6 - 30 ARTARMON RD WILLOUGHBY

On Behalf of LEPC 9 Pty Ltd
20.02.18 ISSUE 01

CONTENTS

2.1 APPROPRIATE INTERFACE BETWEEN BUILDINGS AND PUBLIC DOMAIN

2.1 LEVEL CHANGES AND RELATIONSHIP TO THE PUBLIC DOMAIN

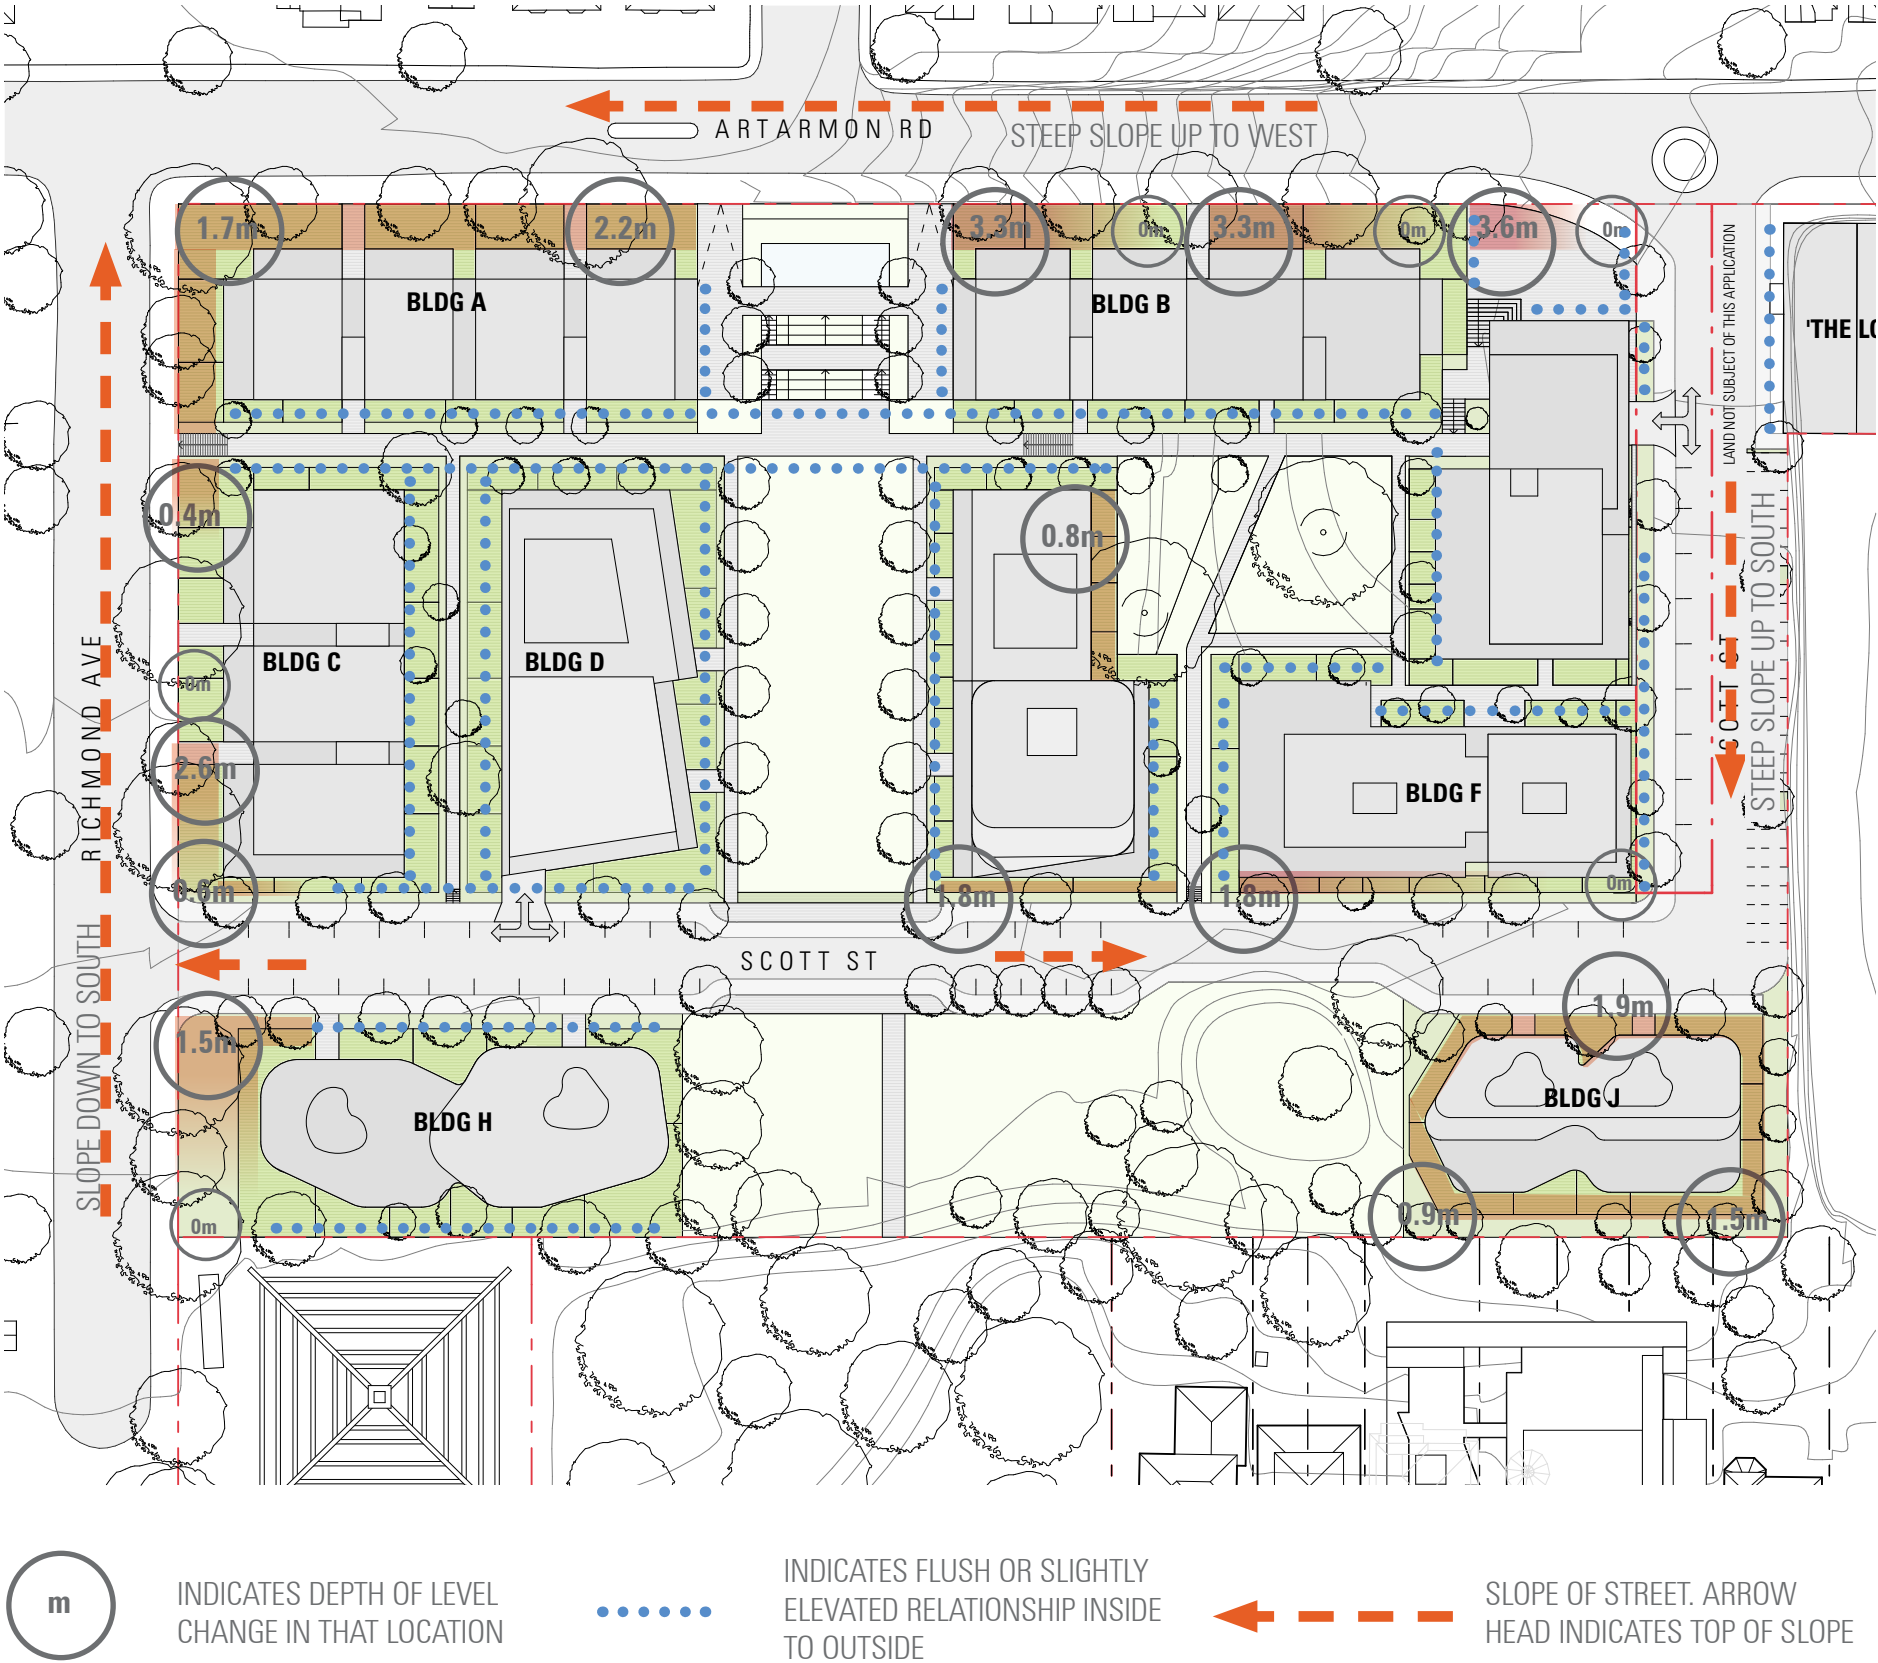
“Further demonstrate the appropriateness of the interface between the proposed buildings and the existing public domain and proposed publicly accessible open space, particularly the dwellings below ground adjacent to Artarmon Road and Richmond Ave.”

The following plan indicates where any frontage to a building sits below the adjoining land level, which in most cases is adjacent to a street. These spaces have a proposed sunken courtyard for private open space. The maximum depth of these sunken courtyards for any apartment is 3.3m and in most cases is significantly less than this. Typically they diminish to 0 along the steep surrounding streets to the site.

Spaces adjoining tree 32 (retained) are slightly sunken by 0.8m to allow the tree to maintain its natural ground level. Building J is also slightly sunken to help reduce visible mass.

All other frontages (noted in a dotted line) have an internal floor plate that is flush or slightly raised above the adjoining land. This level connection to key communal and public open spaces is critical for quality edges to the public open spaces.

2.2 SCOTT STREET SETBACKS

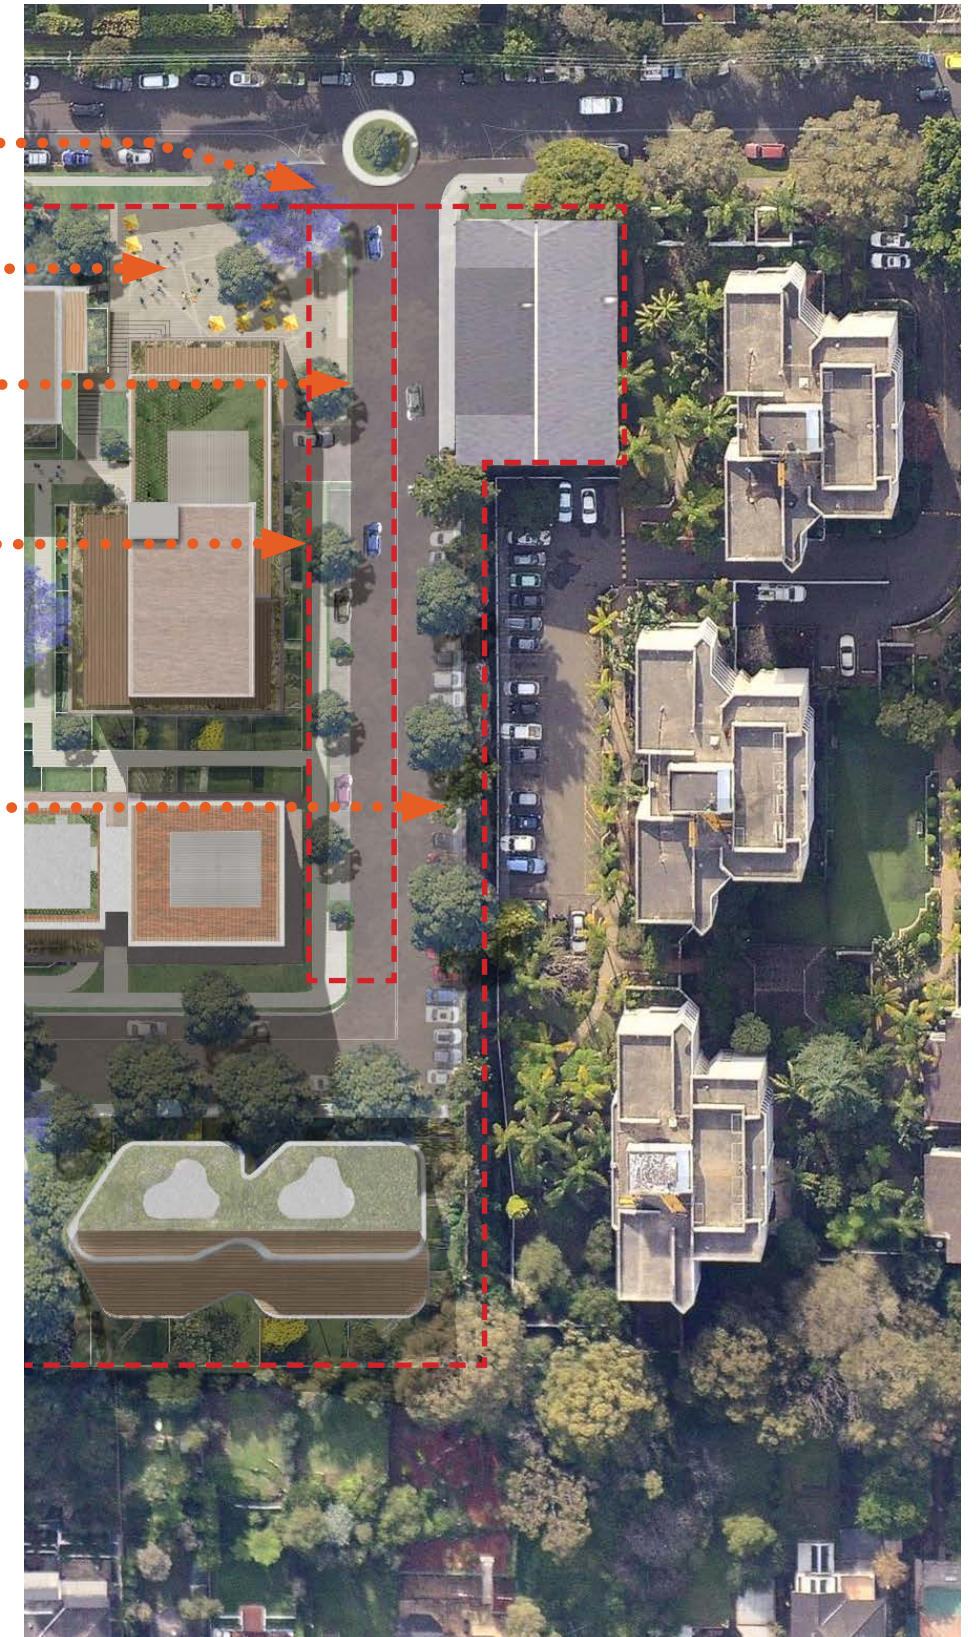
“Reconsider the building setbacks to Scott Street, noting that a zero setback is inconsistent with the established setbacks in the area and throughout the concept plan.”

The boundary line for Scott Street does not align with the kerb line. Whilst the buildings on Scott St may be setback 1m from the boundary, the resulting streetscape and verge will create an overall street consistent with the existing neighbourhood and the southern new section of Scott Street. To setback further from the kerb could create an ambiguous and unusually deep street setback condition, that would not be consistent with the area.

CURB AND FOOTPATH ALTERED TO
SUIT ROUND ABOUT

VILLAGE SQUARE NOW ON THE
WESTERN SIDE OF SCOTT ST

ORIGINAL CURB LINE RETAINED

NO MASSING, OR PRIVATE GARDENS
OVER THE BOUNDARY LINE

RETAINED 90 DEGREES
PARKING ALONG SCOTT STREET
